# RENESAS TECHNICAL UPDATE

Product Category	MPU & MCU		Document No.	TN-16C-A229A/E	Rev.	1.00
Title	Errata to R32C/102 Group, R32C/151 Group, R32C/152 Group, R32C/153 Group, R32C/156 Group, R32C/157 Group User's Manuals Regarding CAN Module		Information Category	Technical Notification		
Applicable Product	R32C/102 Group R32C/151 Group, R32C/152 Group R32C/153 Group, R32C/156 Group R32C/157 Group	Lot No.	Reference Document	User's Manuals: Hardware of Applicable Products

This document describes corrections to the chapter "CAN module" in the User's Manuals: Hardware of the above groups.

**Figure 25.34 Transition between CAN Operating Modes (i = 0, 1)**

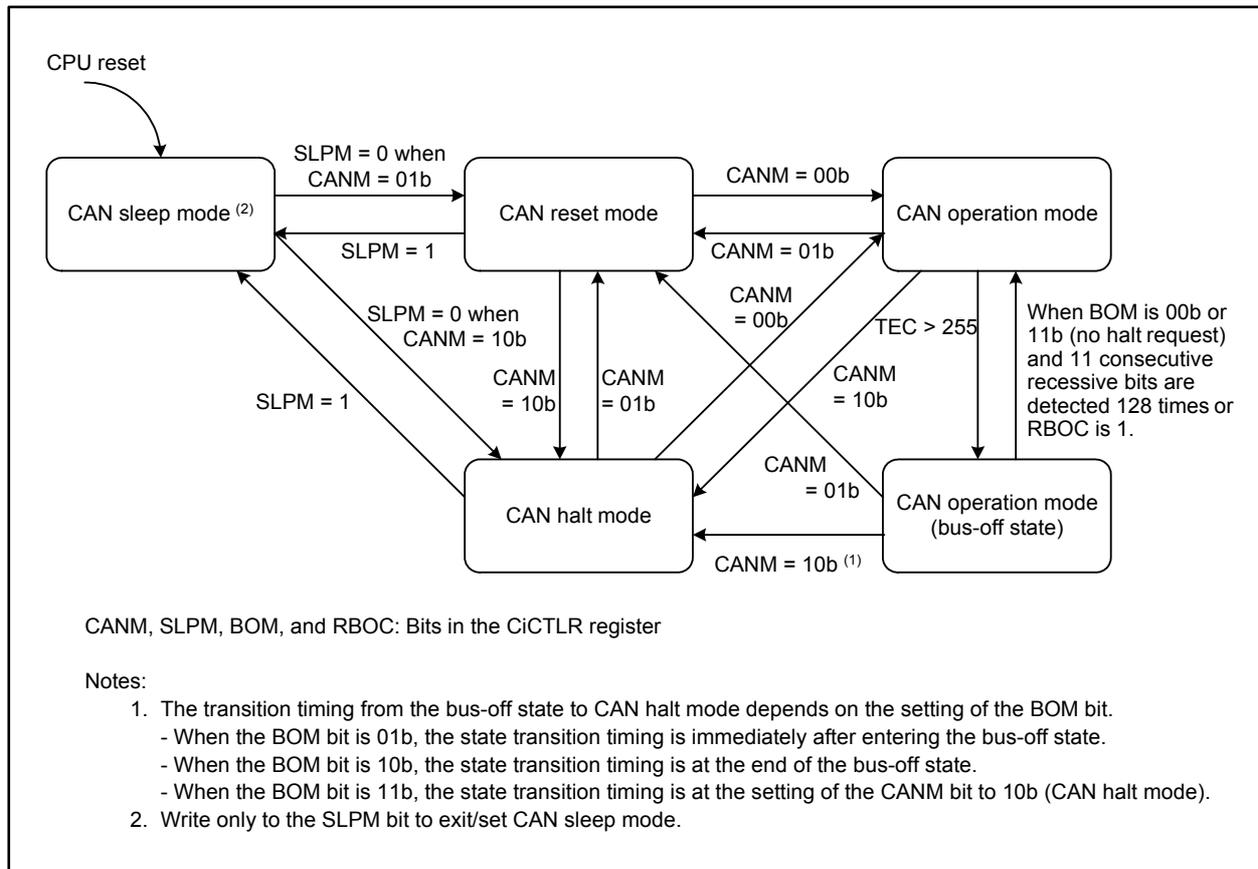
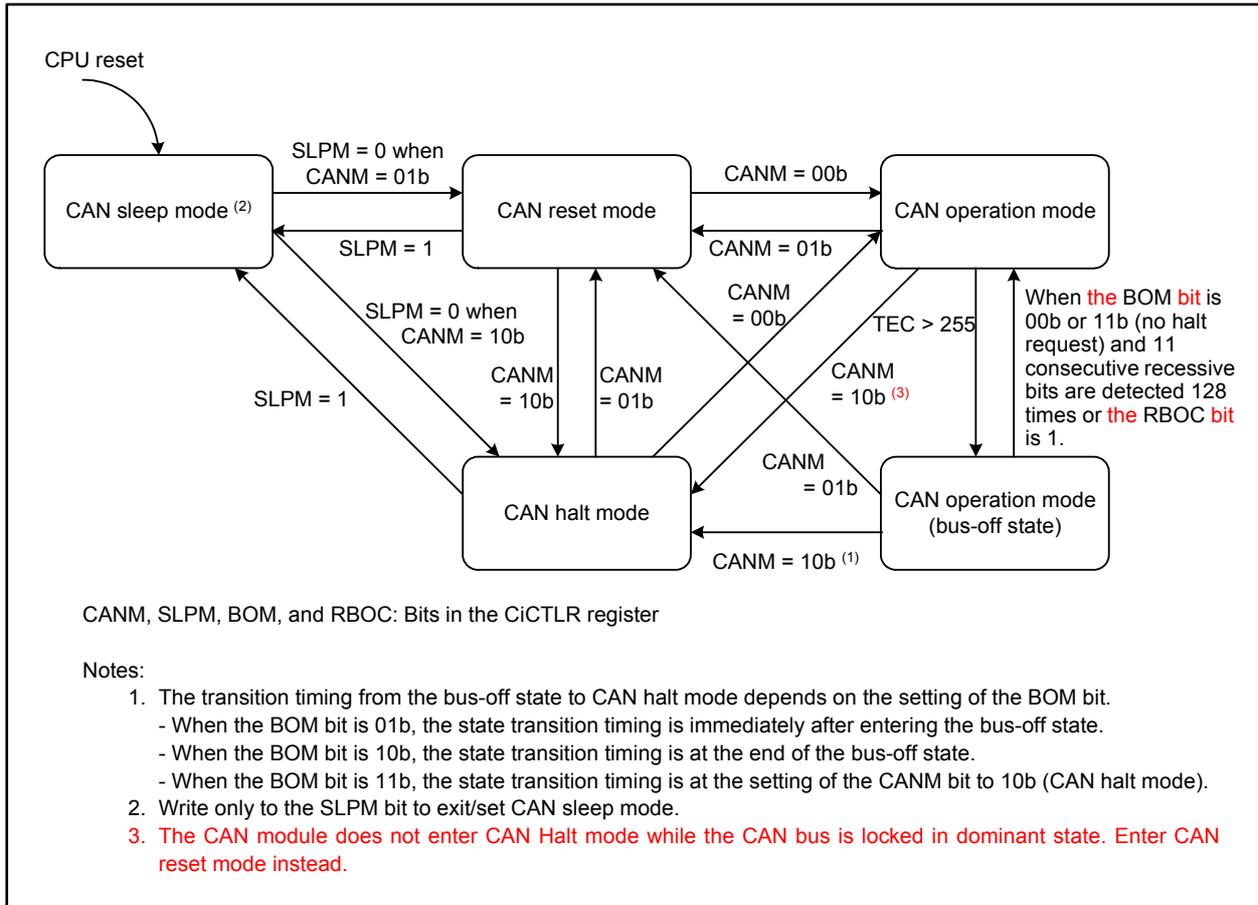
Note 3 is added to Figure 25.34 as follows:
